**RE: Generations at West Mesa
5710 Avalon Rd NW
Grading and Drainage Plan
Engineer's Stamp Date: 04/11/18
Hydrology File: K11D084**

Based upon the information provided in your resubmittal received 04/17/2018, the Grading and Drainage Plan is approved for Building Permit and Grading Permit.

Cypress Civil Development has compiled the following responses to the comment letter received from City of Albuquerque Hydrology Department for the above mentioned project. The responses are listed by heading below:

HEC-HMS

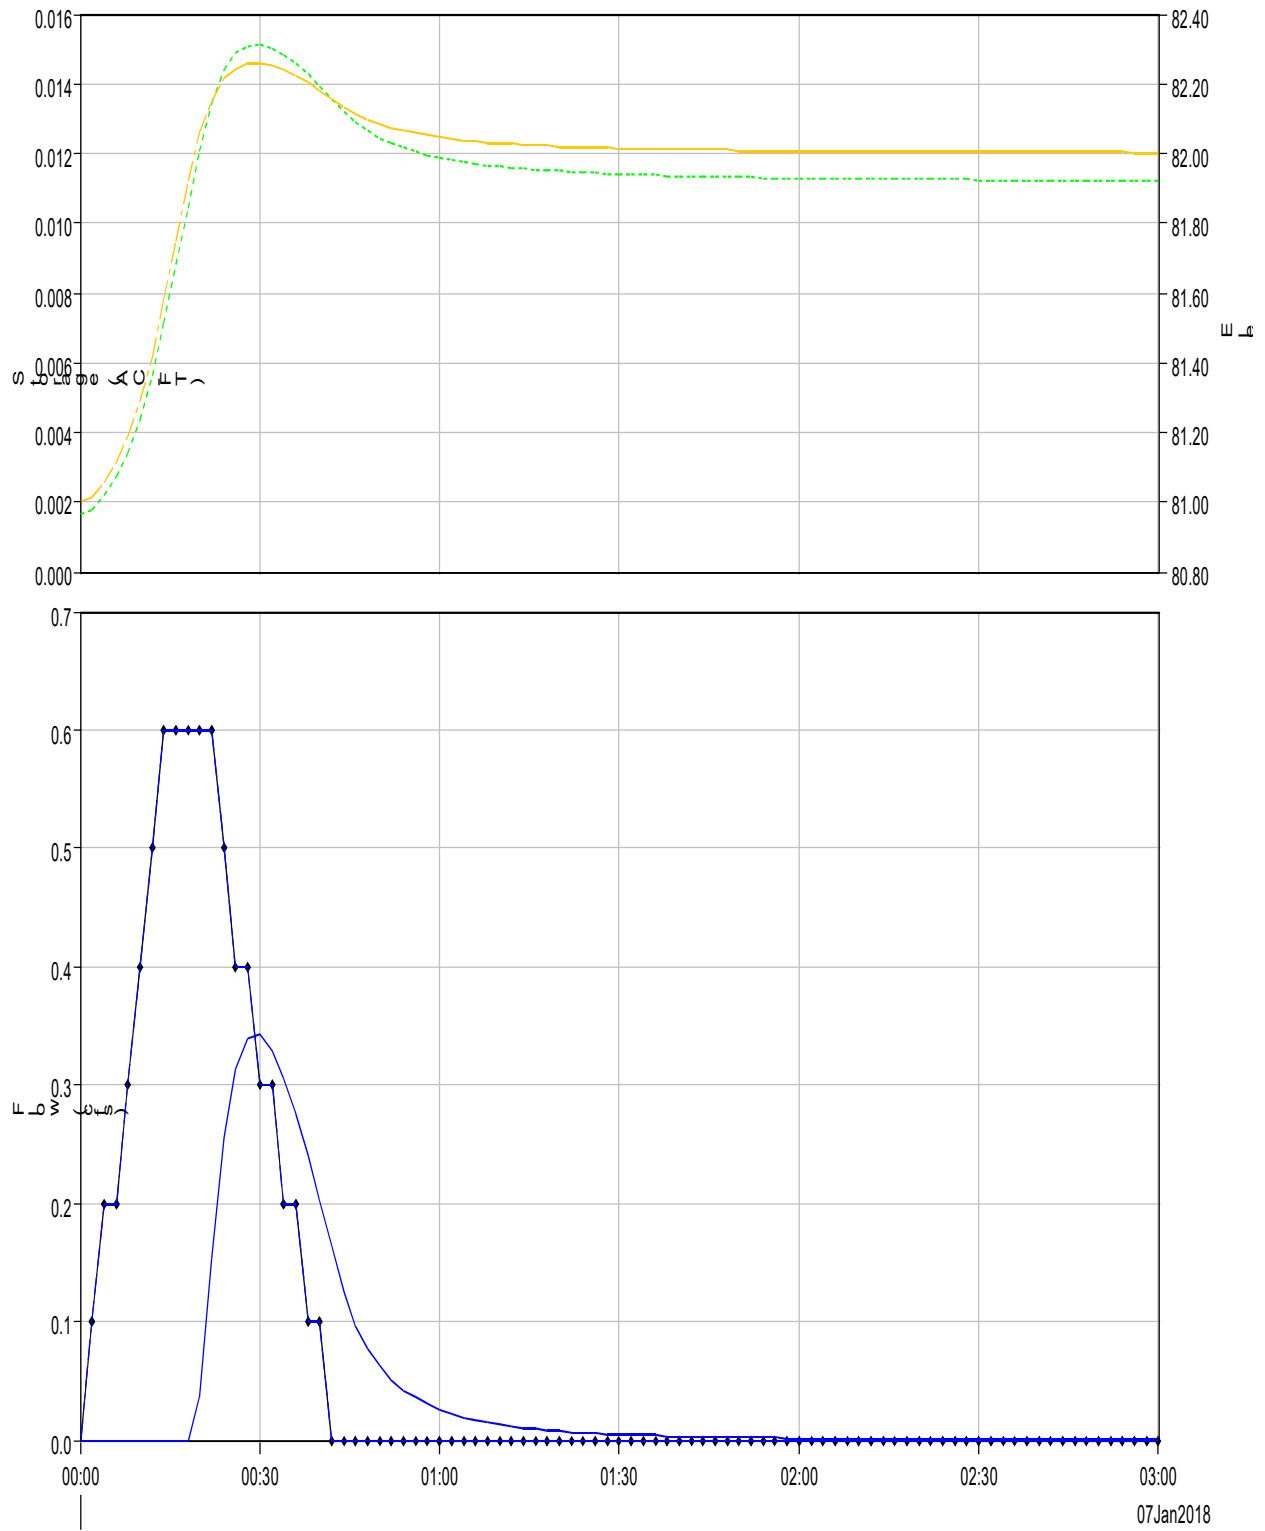
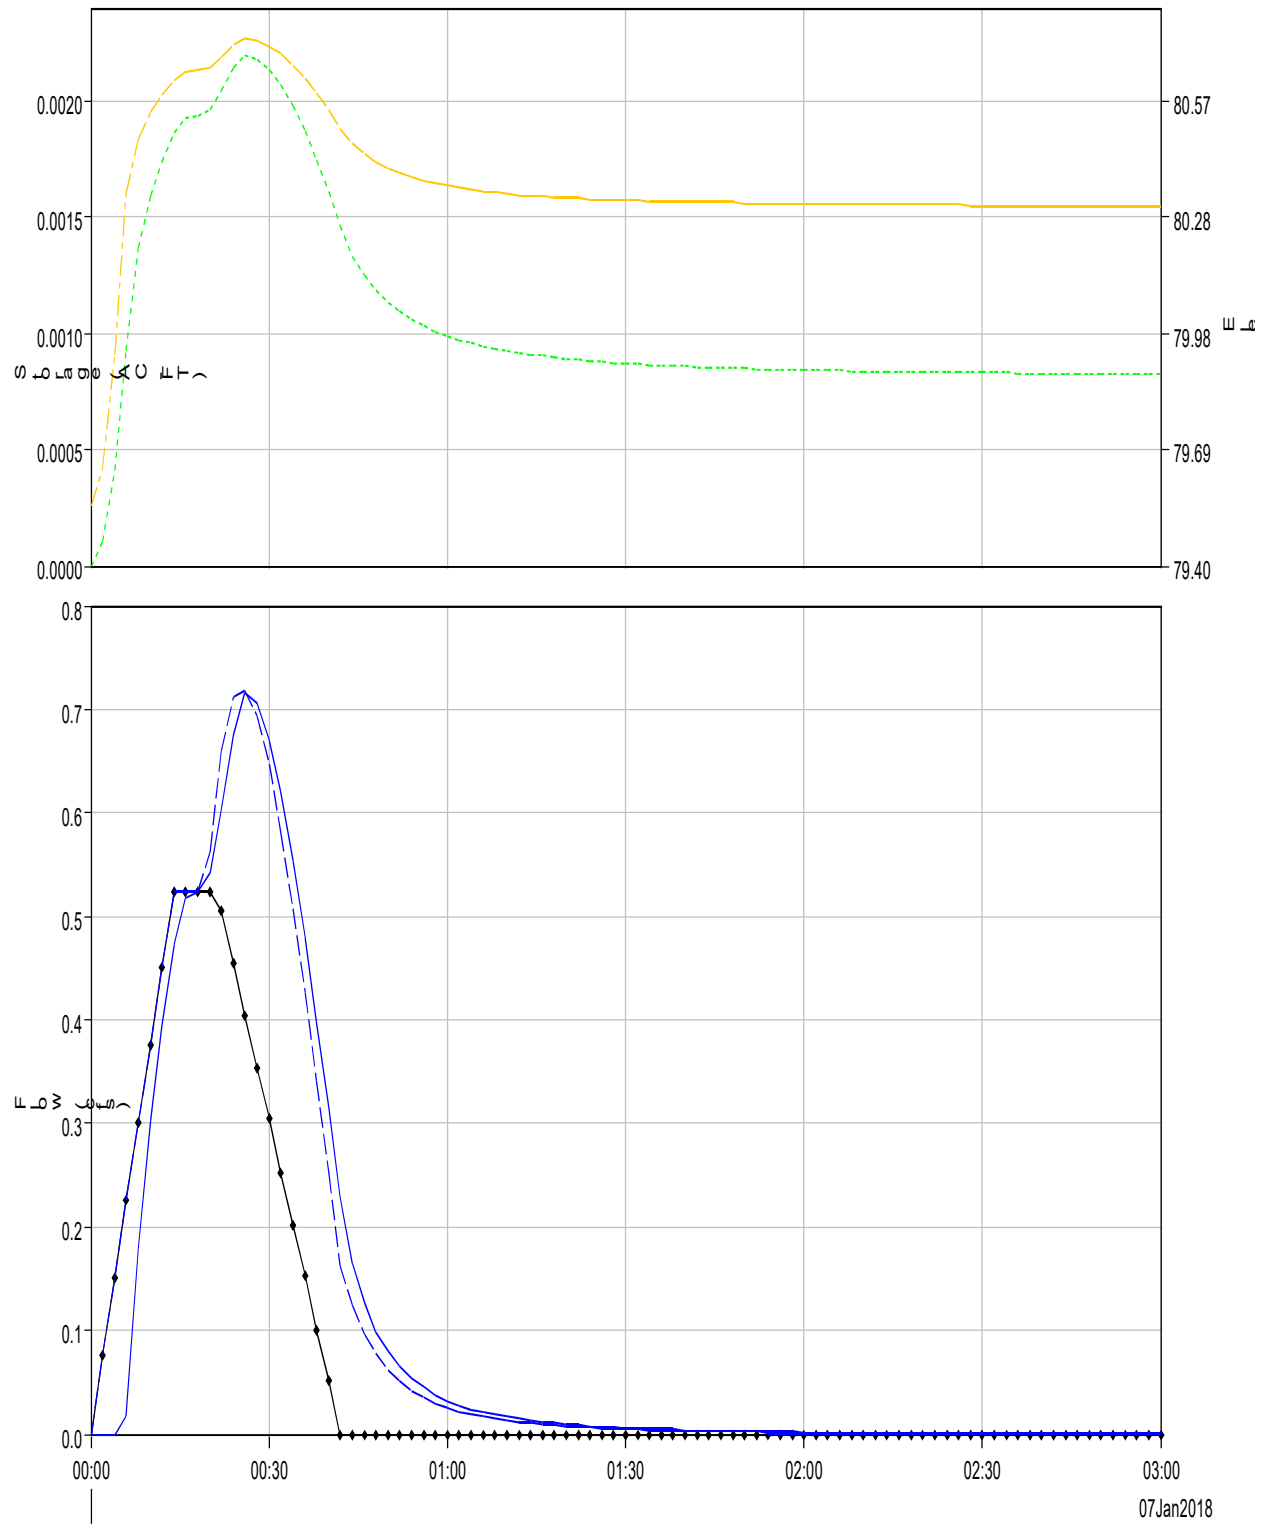
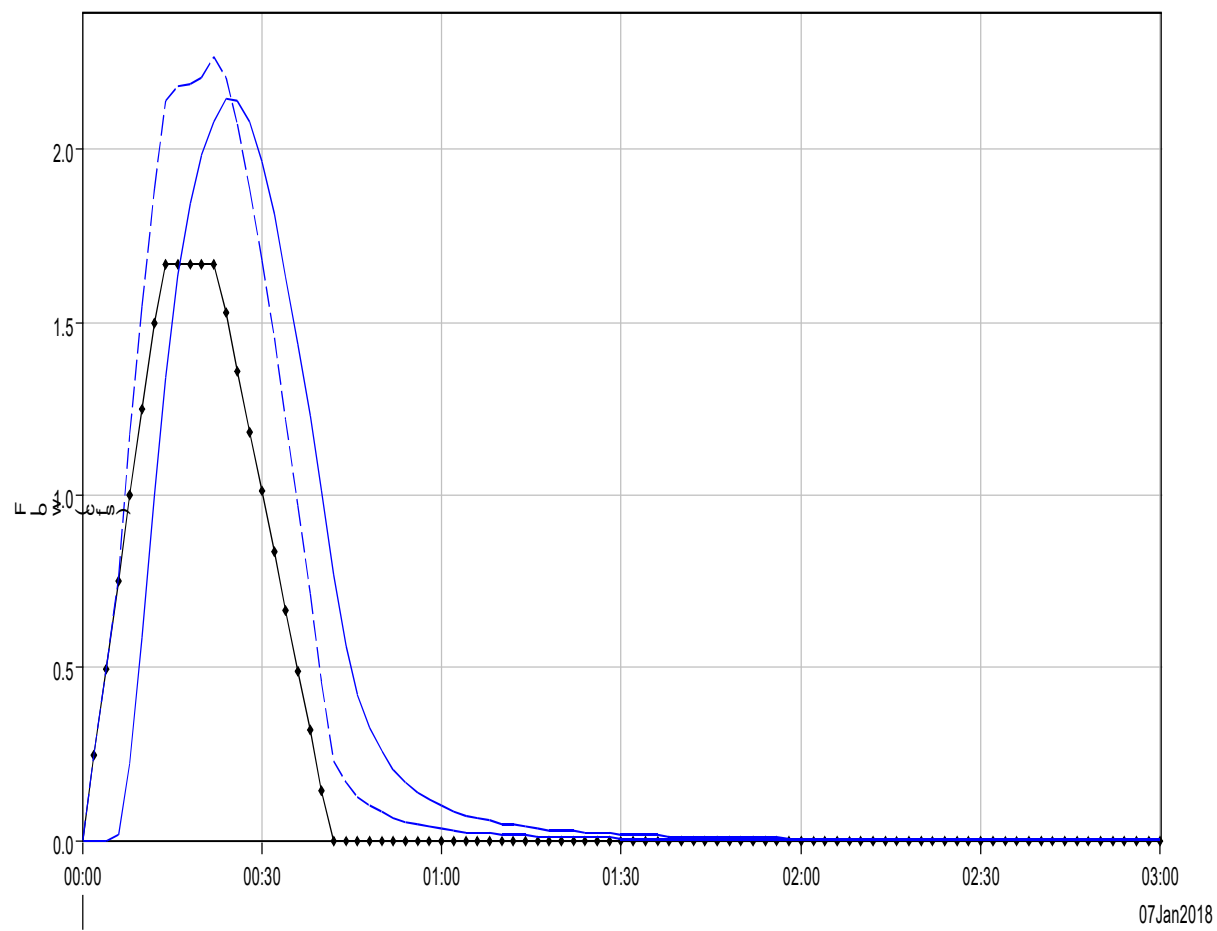
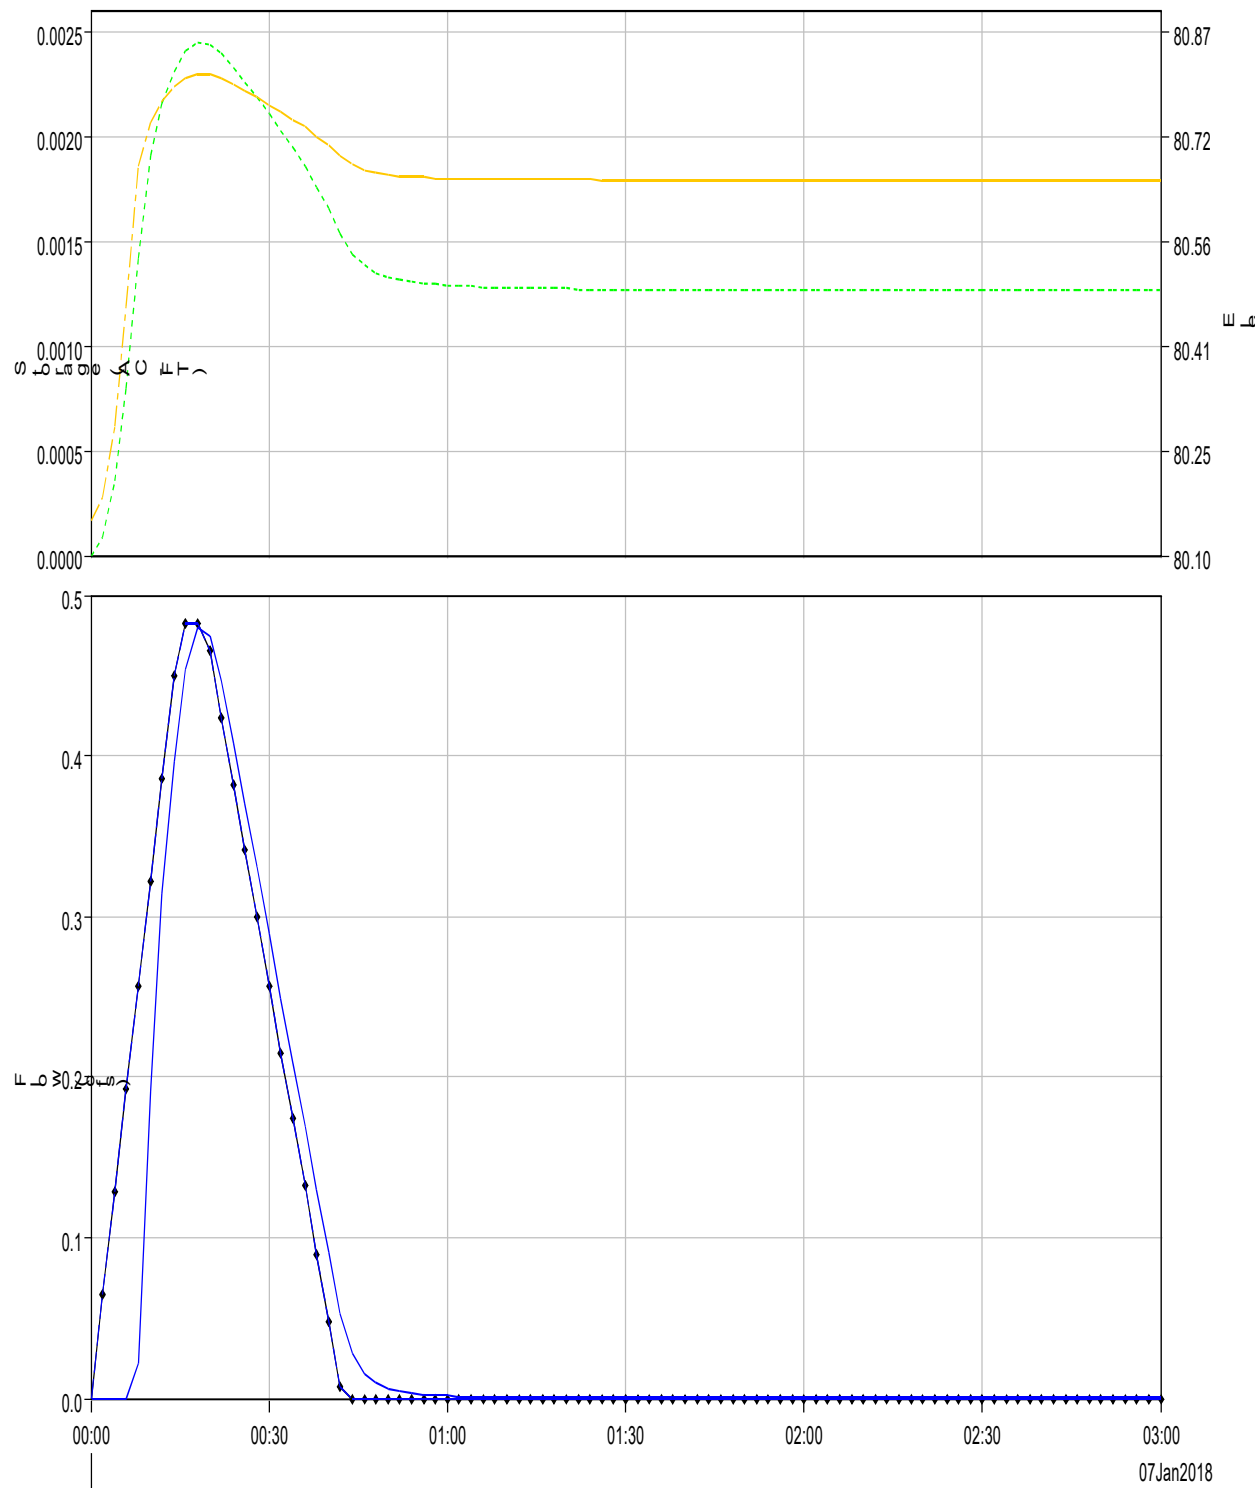
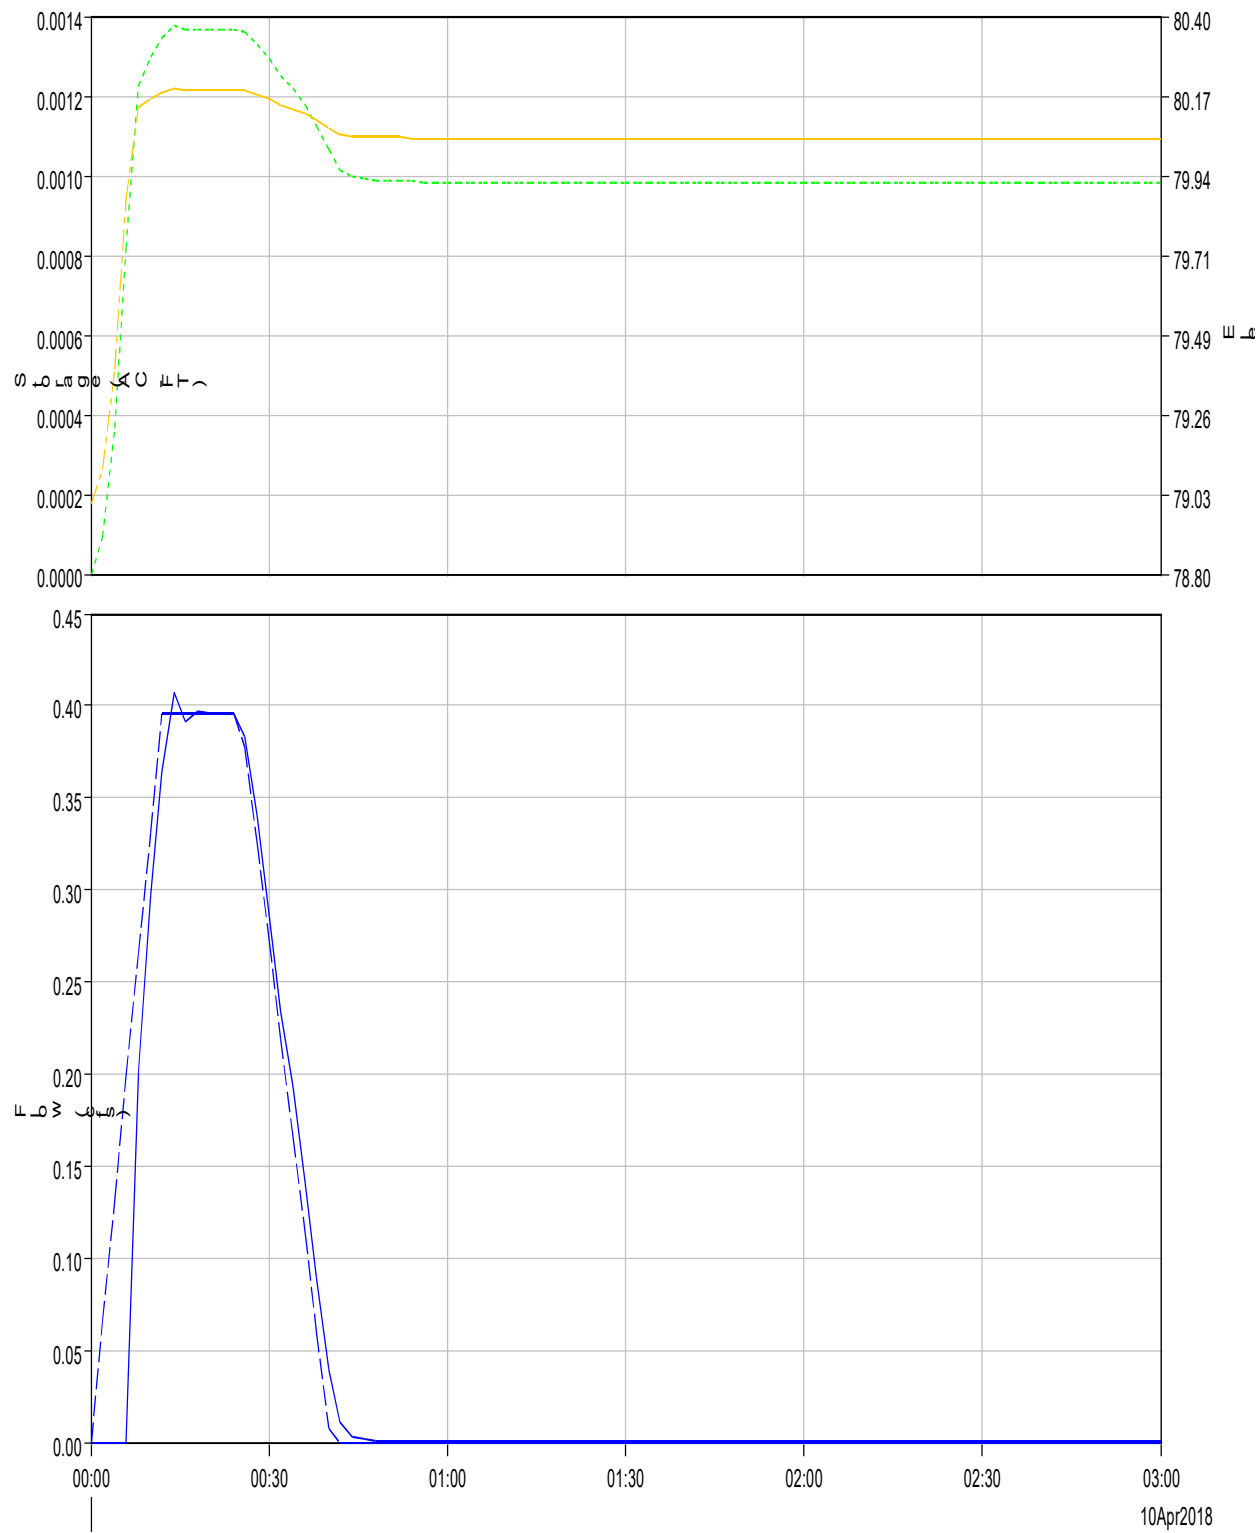
Comment 15 – Acknowledged. Per email discussions, HEC HMS was used to calculate the Q100 that discharges into the right-of-way from the proposed development. The proposed water harvesting/basin areas detain approximately 3.33 cfs, ultimately discharging approximately 10.5 cfs, the same as existing conditions.
